**CONDITIONAL USE PERMIT - CASE NO. 05-CUP-002,
OAK TREE PERMIT - CASE NO. 05-OTP-015
AND
VARIANCE REQUEST - CASE NO. 05-VAR-003**

**FOR THE PROPERTY LOCATED AT
28221 LAURA LA PLANTE DRIVE, AGOURA HILLS**

**CITY OAK TREE/LANDSCAPE CONSULTANT
OAK TREE IMPACT ANALYSIS**

To: Valerie Darbouze, City of Agoura Hills
From: Kay Greeley, Landscape and Oak Tree Consultant
Date: 02/06/07
Re: 05-CUP-002/05-VAR-003/05-OTP-015 – Yvanova, Tvetsana

New Grading Plan - Showing Modifications With Positive Effect on All Tree Impact.

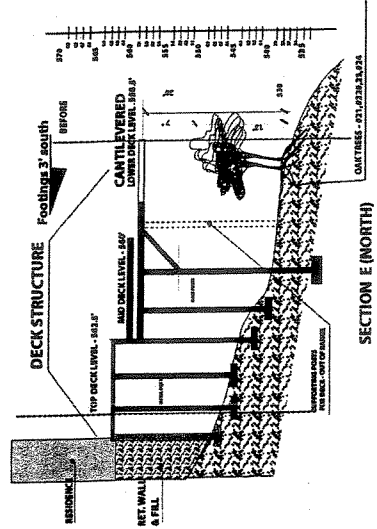
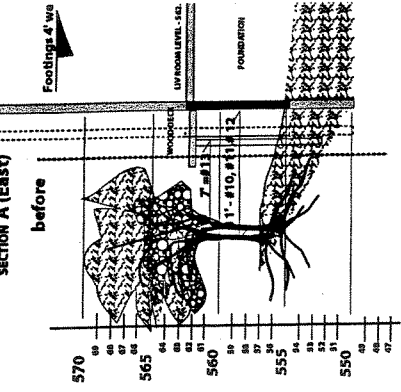
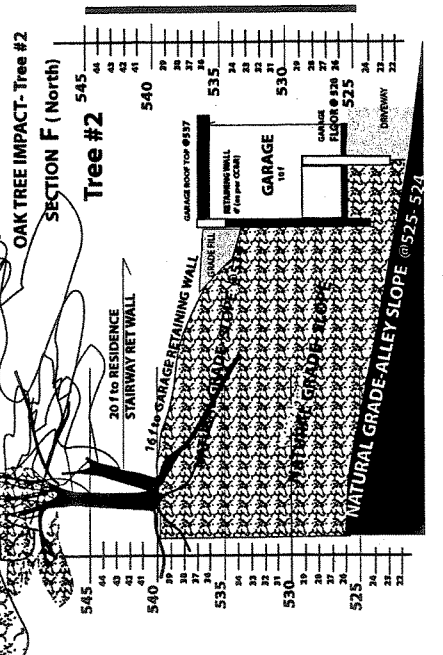
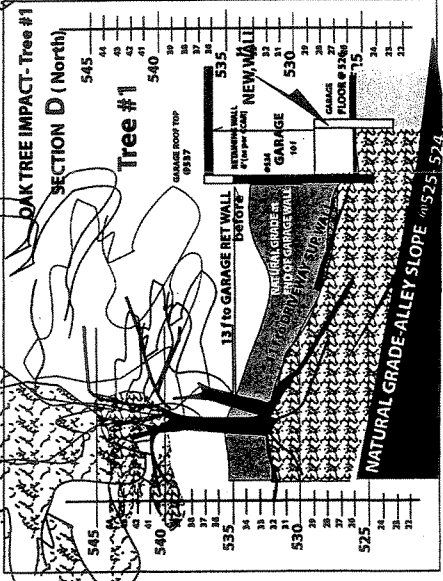
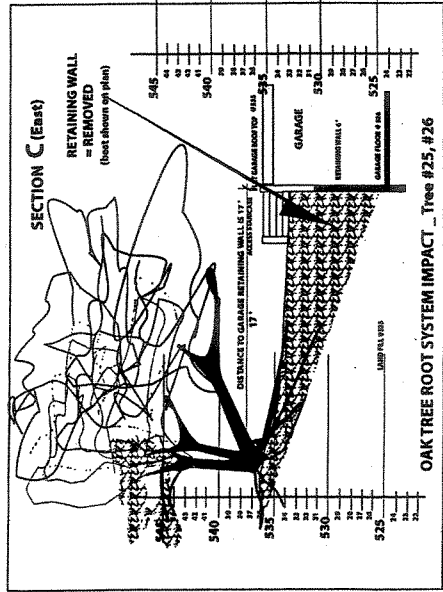
- 5 Major Changes on Plan to Accommodate Oak Tree Preservation:**
1. TREE #1 - Driveway Retaining Wall moved 3' EAST
 2. TREE #25 - Removal of Ret. Wall - Moved access stairs 5' EAST
 3. Scrub Oaks # 21, #23, #24 - Cantilevered Deck Outline modified and Moved 5' SOUTH and FOOTINGS OF RESIDENCE MOVED 3' SOUTH
 4. Scrub Oaks #11, #12 and #13 - FOOTINGS OF RESIDENCE MOVED 4' WEST
